**Regional Water Quality Control Board
Central Valley Region**

**Response to Written Comments on
Tentative Waste Discharge Requirements for**

**City of Alturas,
Alturas Wastewater Treatment Plant**

2 July 2012

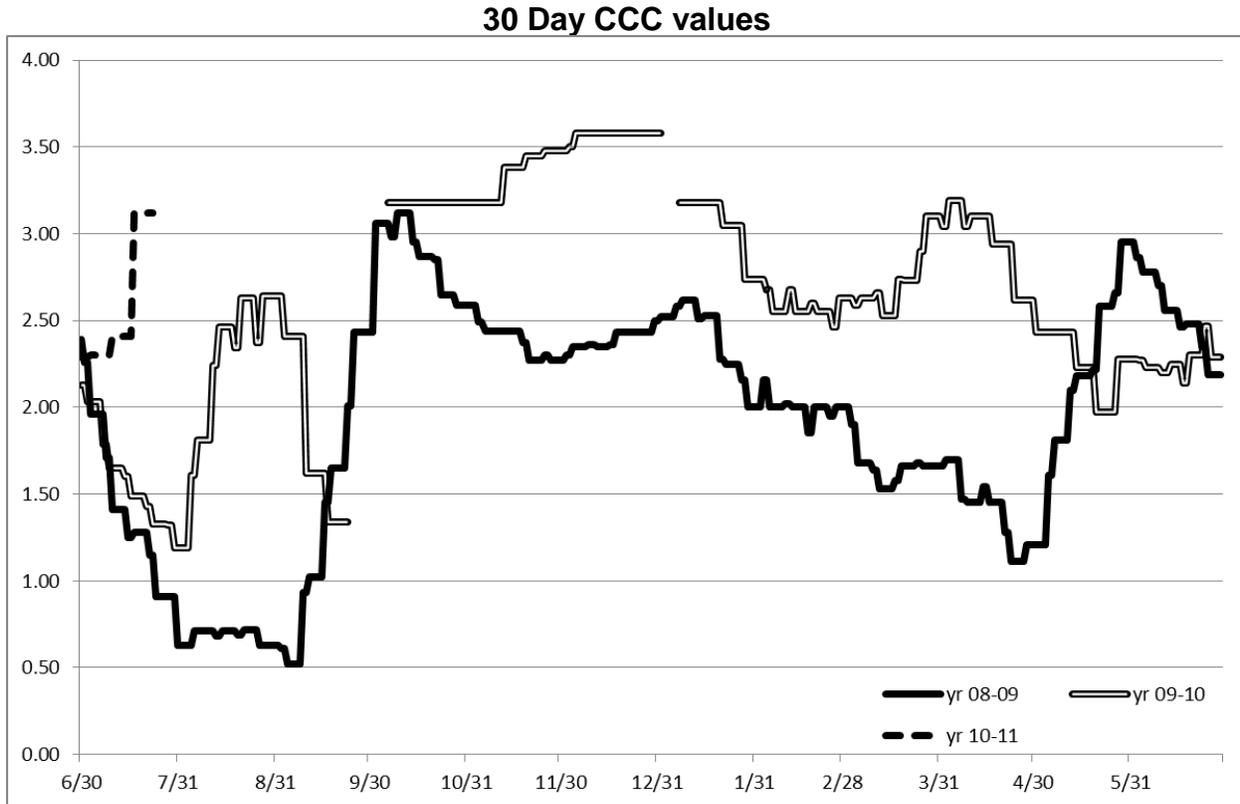
CVCWA asserts that the draft Order's approach to calculating the 30-day criteria continuous concentration (CCC) and ammonia limitations is inconsistent with the Central Valley Water Board's permitting practice, and otherwise improper. CVCWA states that the 30-day CCC should have been calculated using the downstream or effluent pH and temperature data since the Tentative Order does not grant dilution. Further, effluent limitations should not be based on the minimum of the 30-day CCCs calculated from pH and temperature pairs but that the 1/10th percentile should be used.

Although the 2007 Atwater permit did not set any sort of precedence, Central Valley Water Board staff reviewed the approach to ammonia limit calculations used in the proposed permit, the Atwater permit, and other more recent Central Valley Water Board permits. Central Valley Water Board staff has made revisions to the proposed permit to be more consistent, when appropriate, with the approach taken in these other permits. Specifically, revisions have been made to use paired downstream receiving water temperature and pH data to calculate the CCCs and 30-day running average CCCs. In addition, the lowest 1/10th percentile is used in the 30-day CCC selection. These corrections result in the ammonia AMEL changing from 0.40 mg/L to 0.50 mg/L and the ammonia MDEL changing from 0.50 mg/L to 0.80 mg/L. Relevant portions of the permit have been updated accordingly.
